MYSTERY COVE WATERPARK

DRC OVERVIEW - 2024 CURRENT PLAN

8 May 2024

ROOF PLAN: SCALE 1' = 1/100"

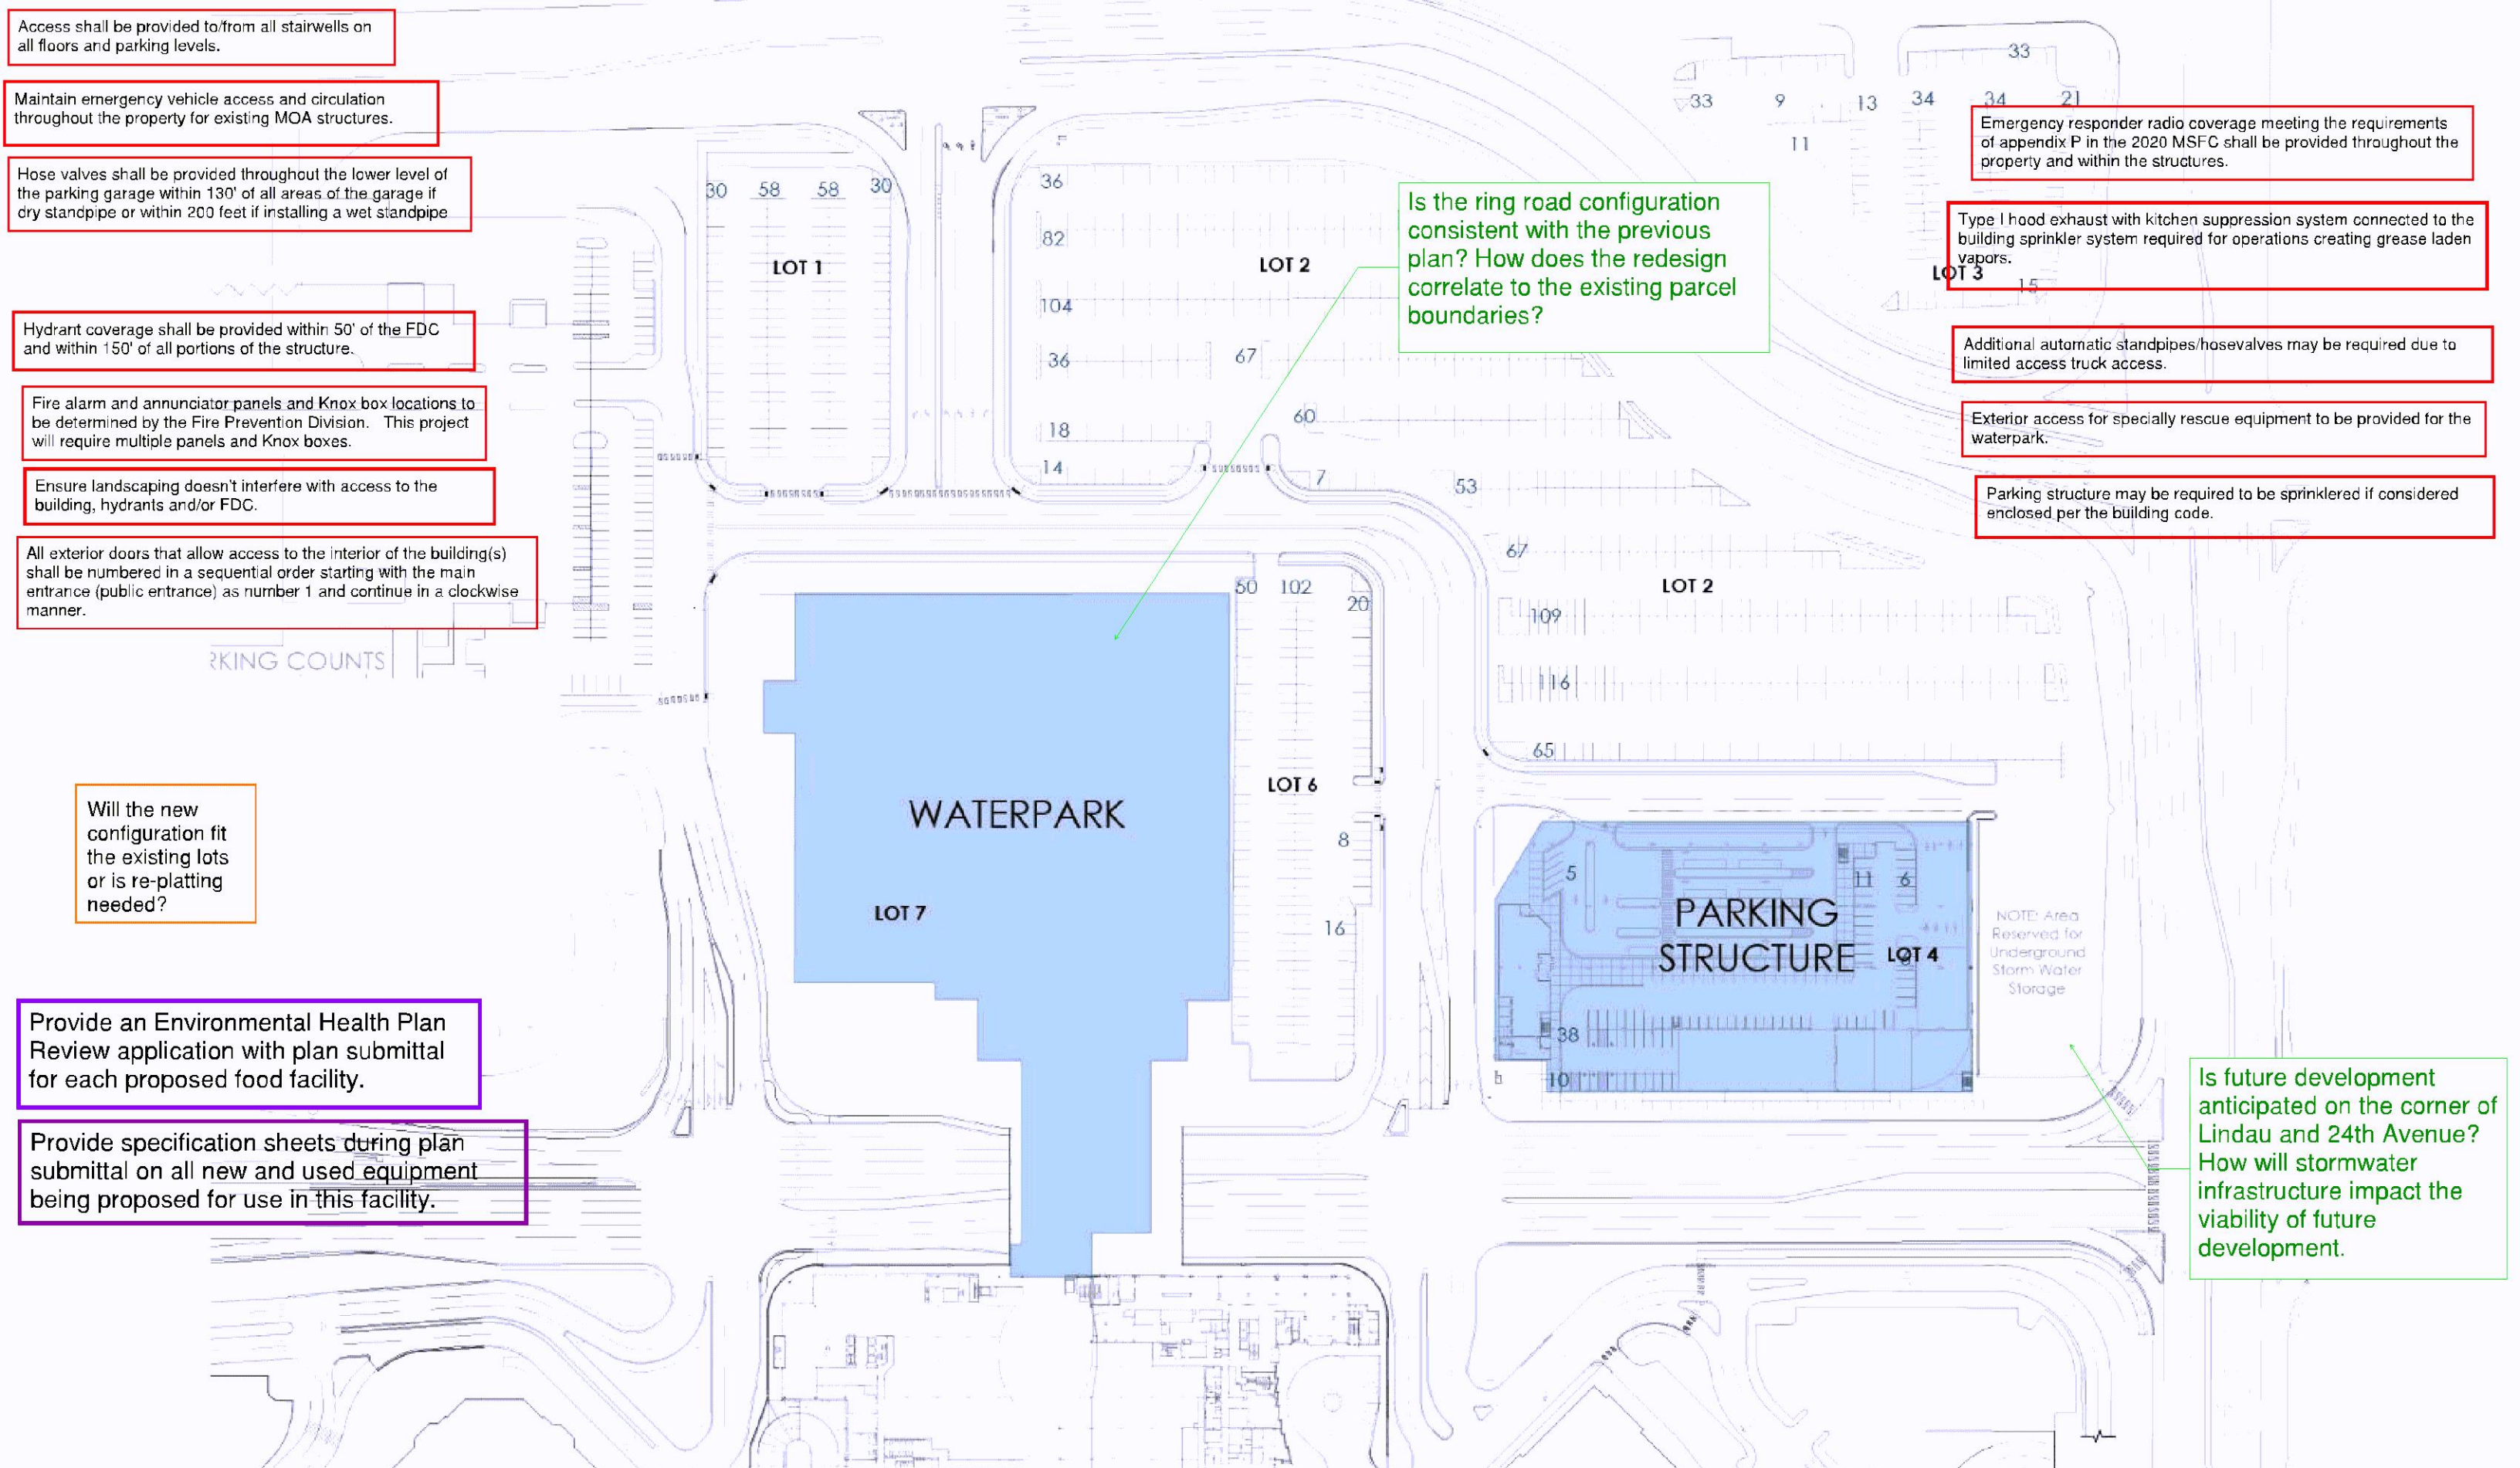
Access shall be provided to/from all stairwells on all floors and parking levels.

Maintain emergency vehicle access and circulation throughout the property for existing MOA structures.

Hose valves shall be provided throughout the lower level of the parking garage within 130' of all areas of the garage if dry standpipe or within 200 feet if installing a wet standpipe

Hydrant coverage shall be provided within 50' of the FDC and within 150' of all portions of the structure.

Fire alarm and annunciator panels and Knox box locations to be determined by the Fire Prevention Division. This project will require multiple panels and Knox boxes.

Ensure landscaping doesn't interfere with access to the building, hydrants and/or FDC.

All exterior doors that allow access to the interior of the building(s) shall be numbered in a sequential order starting with the main entrance (public entrance) as number 1 and continue in a clockwise manner.

Will the new configuration fit the existing lots or is re-platting needed?

Provide an Environmental Health Plan Review application with plan submittal for each proposed food facility.

Provide specification sheets during plan submittal on all new and used equipment being proposed for use in this facility.

Is the ring road configuration consistent with the previous plan? How does the redesign correlate to the existing parcel boundaries?

Emergency responder radio coverage meeting the requirements of appendix P in the 2020 MSFC shall be provided throughout the property and within the structures.

Type I hood exhaust with kitchen suppression system connected to the building sprinkler system required for operations creating grease laden vapors.

Additional automatic standpipes/hosevalves may be required due to limited access truck access.

Exterior access for specially rescue equipment to be provided for the waterpark.

SITE + PARKING PLAN

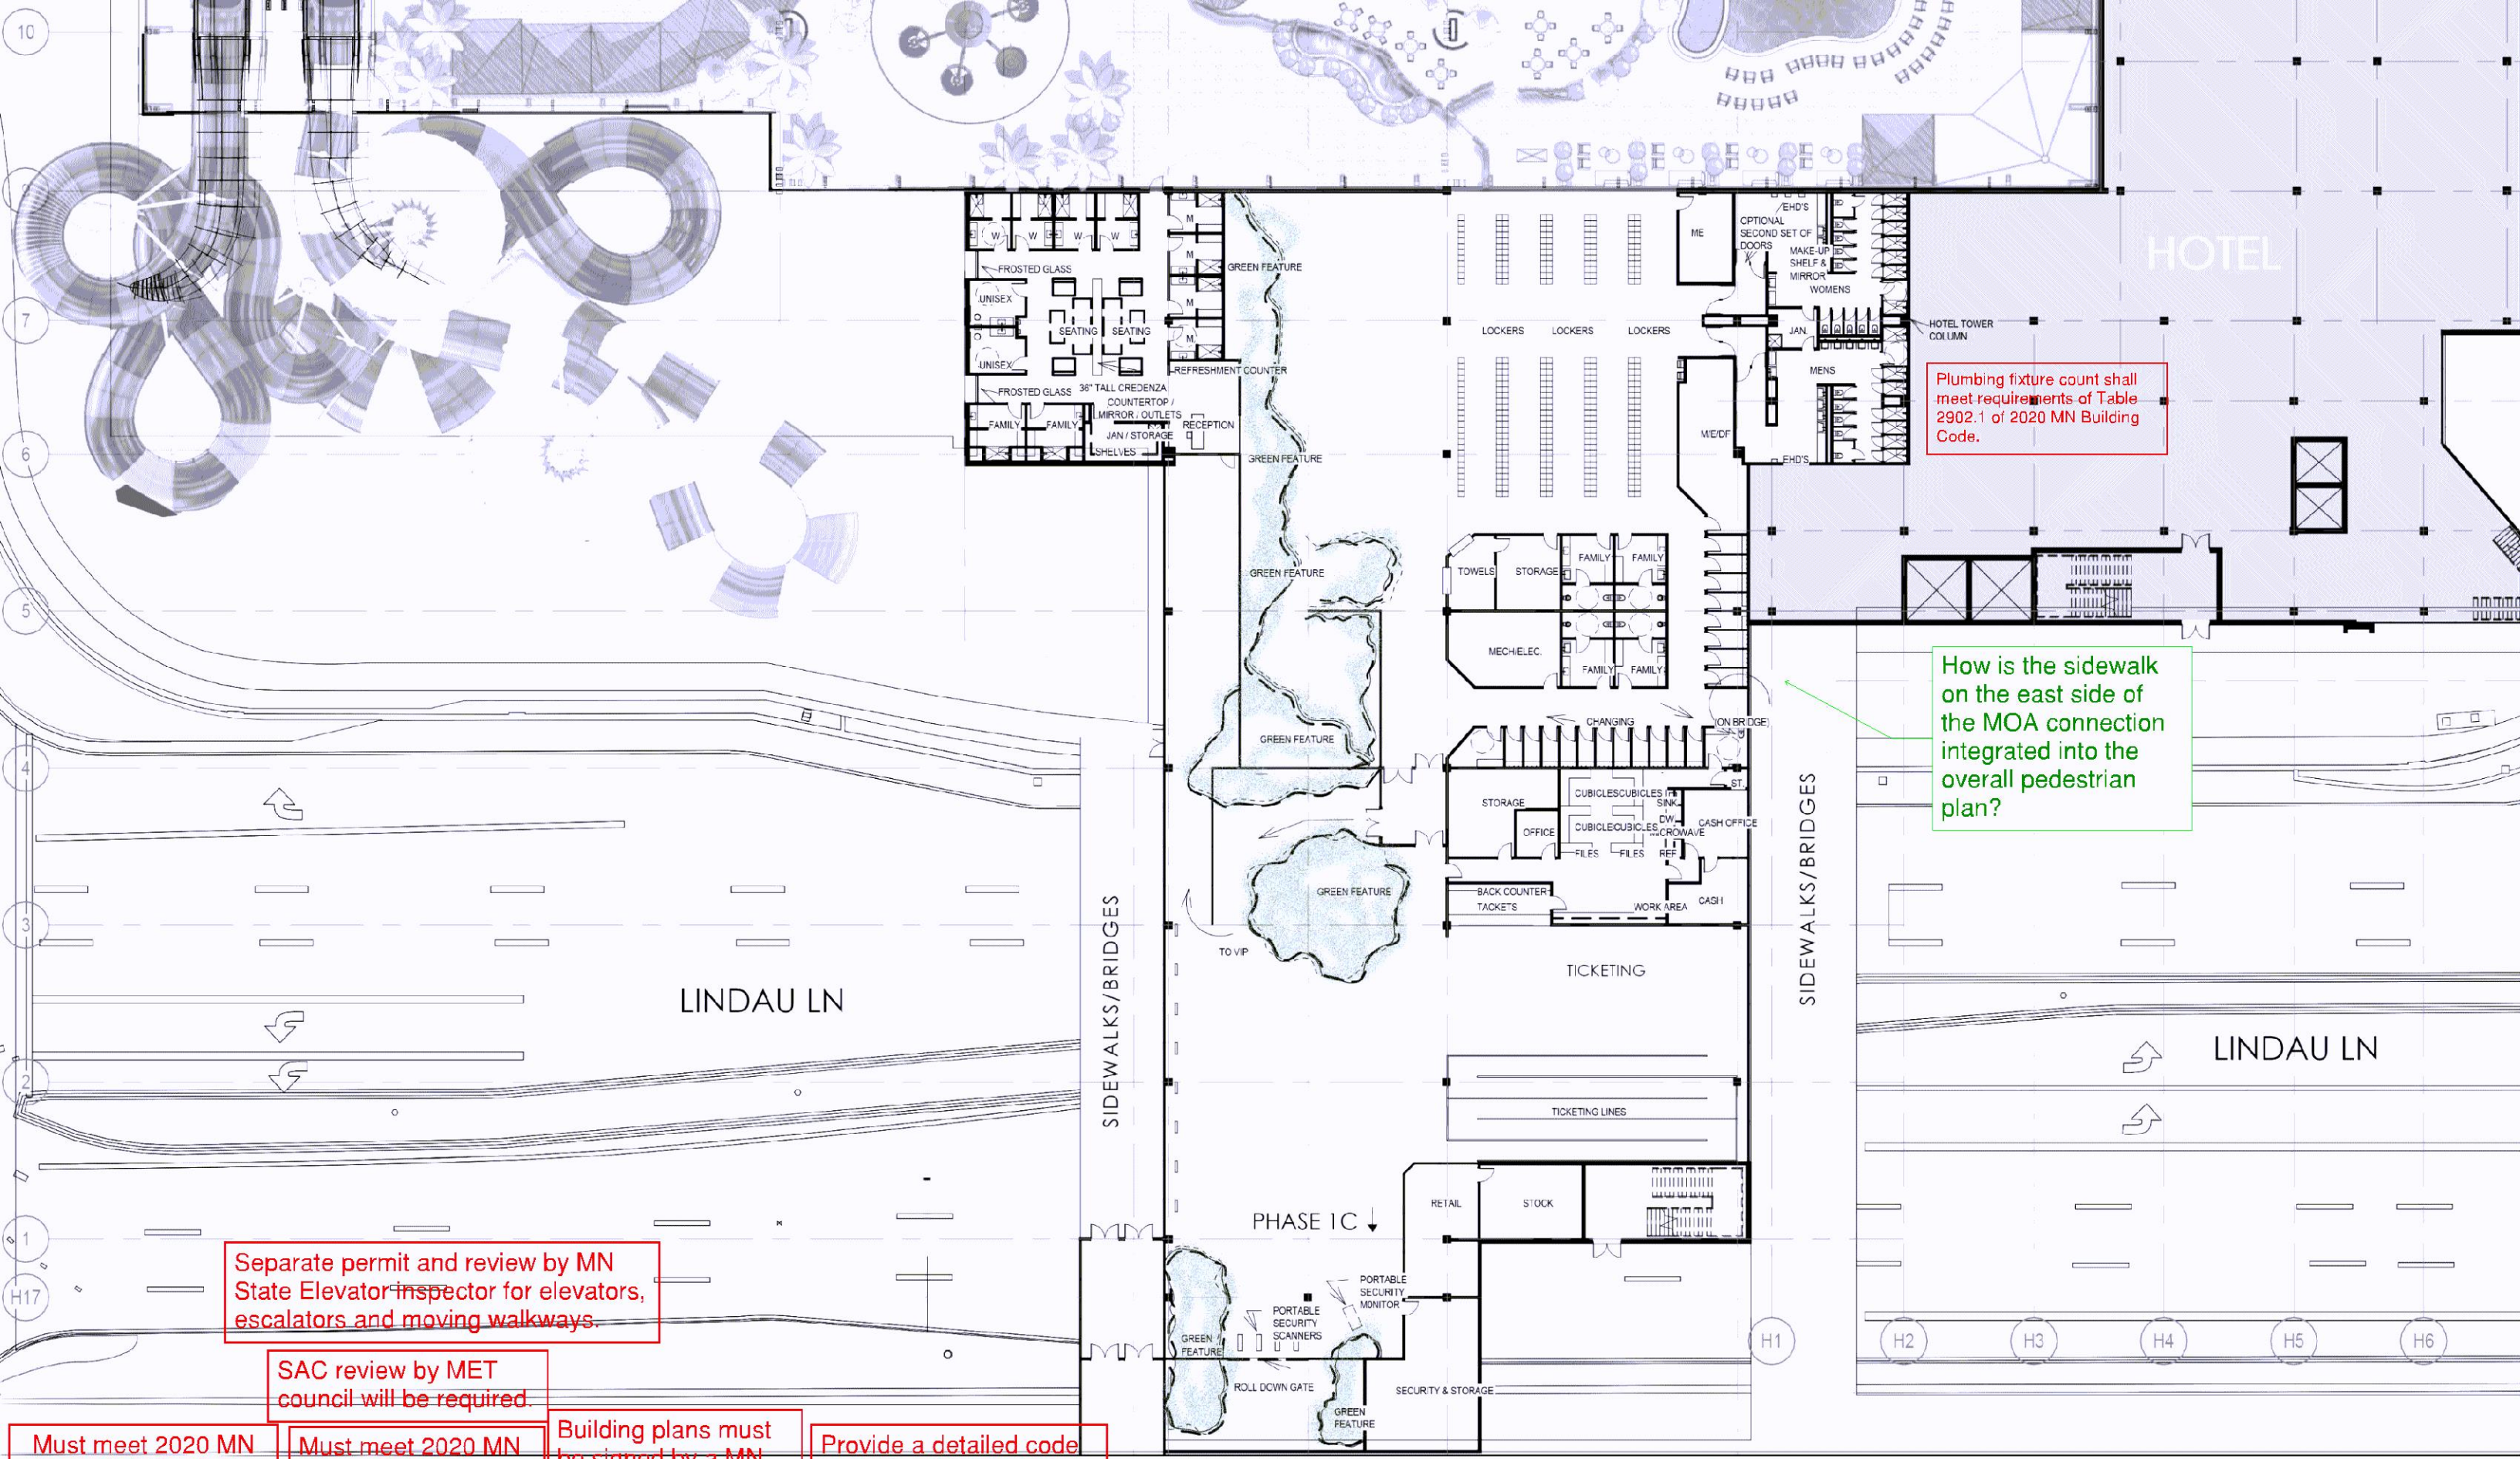
Parking structure may be required to be sprinklered if considered enclosed per the building code.

Is future development anticipated on the corner of Lindau and 24th Avenue? How will stormwater infrastructure impact the viability of future development.

A looped water supply feeding a single, combined water service is required for the domestic and fire service water demand. Standpipes required in all stairwells and hose valves required for the domestic and fire service water demand.

Plumbing fixture count shall meet requirements of Table 2902.1 of 2020 MN Building Code.

How is the sidewalk on the east side of the MOA connection integrated into the overall pedestrian plan?

Separate permit and review by MN State Elevator Inspector for elevators, escalators and moving walkways.

SAC review by MET council will be required.

Must meet 2020 MN State Building Code

Must meet 2020 MN Accessibility Code.

Building plans must be signed by a MN licensed architect.

Provide a detailed code analysis with the plans.

SECTIONS A & B

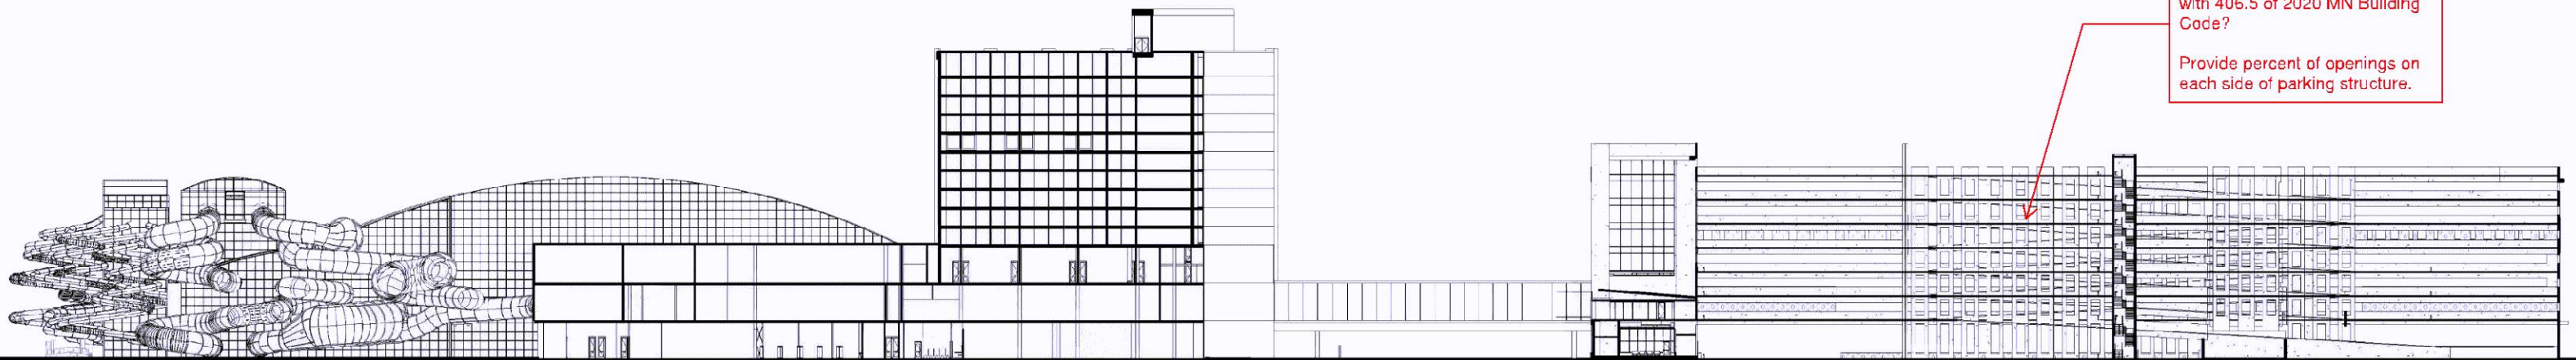
Is the parking ramp an open parking garage - in compliance with 406.5 of 2020 MN Building Code?
Provide percent of openings on each side of parking structure.
